PCN #: 1776
DATE: 11MAY2018
EXPECTED PCN SHIP DATE: 11MAY2018

☒ PRODUCT CHANGE NOTICE

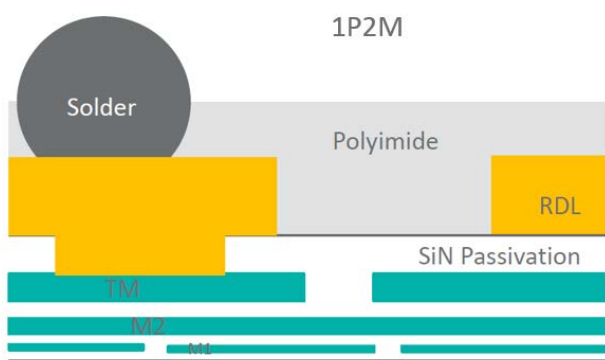
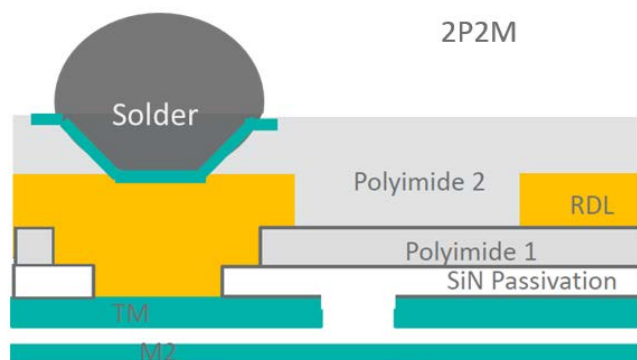
<p>CHANGE FROM: Devices processed with one layer of polyimide and two metal redistributed layers (1P2M) bump flow</p> 	<p>CHANGE TO: Devices processed with two layers of polyimide and two metal redistributed layers (2P2M) bump flow</p> 
---	---

JUSTIFICATION: This change is required to improve the quality and reliability of Maxim's Flip chip QFN package. Maxim has qualified both UTL (UTAC Thai Limited) and JCAP (JIANGYIN CHANGDIAN ADVANCED PACKAGING CO. LTD, Jiangsu China) to assemble devices with the 2P2M bump process flow. Reference qualification results, report R29667 and R29618. There is no change to the form, fit or function of the devices.
